TECHNICAL BULLETIN – TB010

Gen II Connection Kit - Part Number OC15SUK12B

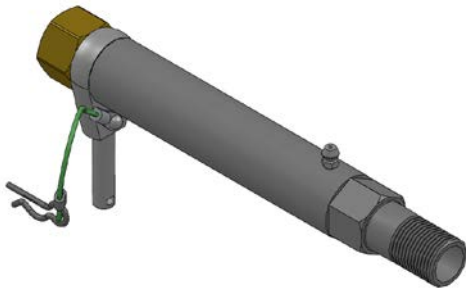
A new guide tube assembly for Mercruiser and Volvo Sterndrives was introduced in July 2012. The new guide tube was introduced to simplify the assembly and installation of the connector kit for these Sterndrives. It replaces the previous guide tube assembly, and will be supplied from the factory on all future shipments of this connector kit.

The NEW guide tube assembly will replace the OLD guide tube assembly as shown below:
